STAFF REPORT

Architectural Design Review

LOCATION: 640 Newmark Avenue, Coos Bay, Oregon 97420
(T.25, R.13, S.20BB Tax Lot 2200/2300)

SUBJECT: **ARCHITECTURAL DESIGN REVIEW APPLICATION #187-ZON16-018**
Façade improvements on the south and east elevations of the existing structure. Proposed improvements include refinish and paint concrete shell, replace Three windows on south elevation, adding a marquee over south entrance and adding exterior lighting on the Wall Street elevation.

NEW SOUTH FACADE (NEWARK)

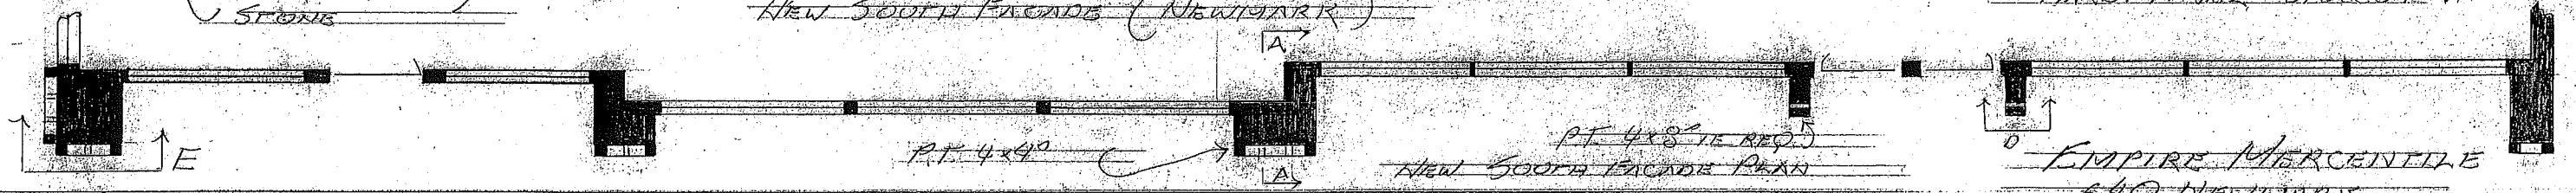
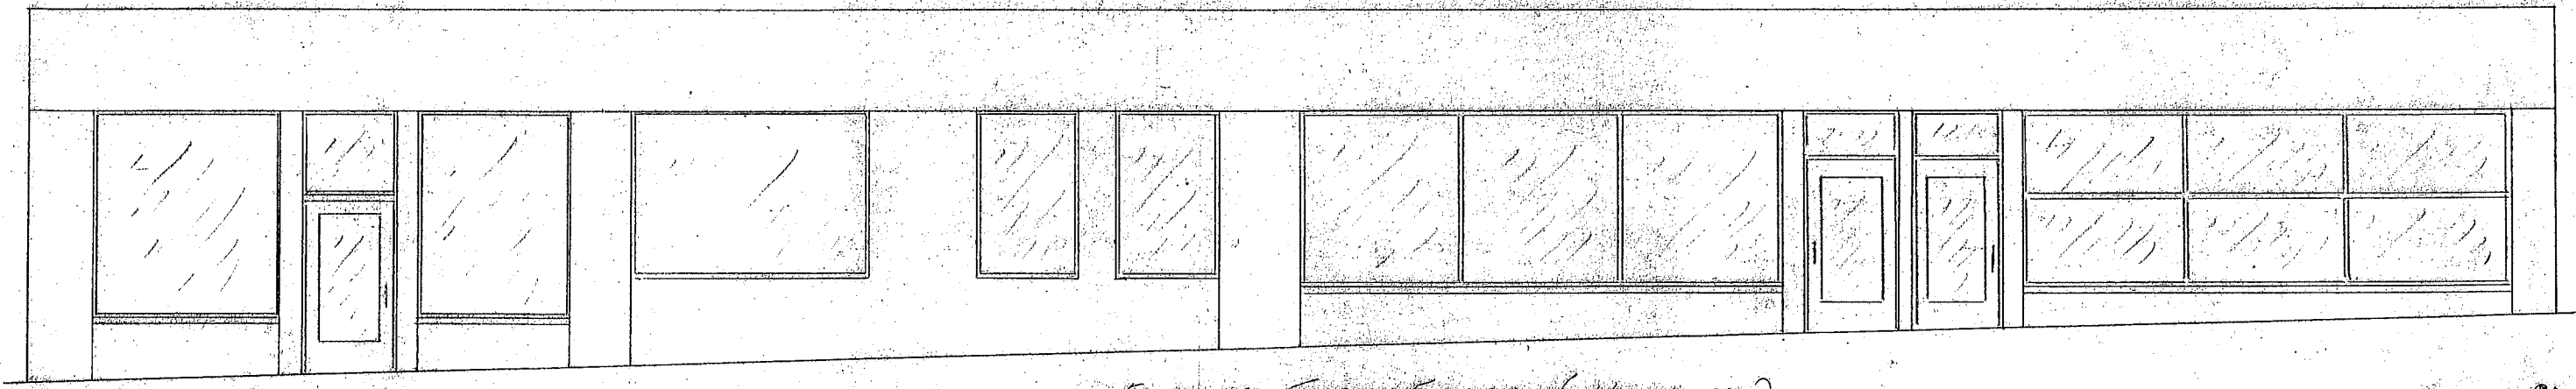
- A3. The existing wood canopy (on the south elevation) will be removed and replaced with a “Dark Grey” metal canopy that extends about 12-inches away from the structure. The canopy will be extended onto the west elevation about 20-feet (past the existing window). The green paint will be removed from the cement abutting the sidewalk. These changes will provide a human scale that is comfortable for and attractive to pedestrians.

- A4. The existing painted rock façade on the south elevation will be removed and replaced with the “Black Rundle” Alpine Ledge stone.

- A5. The deteriorated T1-11 siding on the south elevation will be removed and a Hardie product that resembles stucco will be installed.

- A7. Three windows on the south elevation will be removed and the area will be framed in to provide an indoor display area with a three small windows added at the top for lighting.

- B1. The existing painted rock façade on the south elevation will be removed and replaced with the “Black Rundle” Alpine Ledge stone. The deteriorated T1-11 siding on the south elevation will be removed and a Hardie product that resembles stucco will be installed. The recessed areas on the west elevation (Wall Street) will be framed in and sided with the same Hardie product as the south elevation. The west elevation will be repainted. The south and west elevations will be painted a medium warm Grey.

The existing wood canopy will be replaced with a "Dark Grey" metal canopy that extends about 12-inches away from the structure. Three windows will be removed and the area will be framed in to provide an indoor display area with a three small windows added for lighting.

- 1. *Glass in the windows shall be clear, lightly tinted or ornamental stained glass. Translucent glazing should be used only for restrooms.*
- 2. *Security lighting on the Wall Street elevation shall be integrated with architectural elements. Light fixtures must be in keeping with the historic styles are encouraged. Light fixtures must not compete with city-furnished sidewalk period lights. Building lights should be metal halide or incandescent and are to be directed away from pedestrians and street traffic so as to avoid glare.*
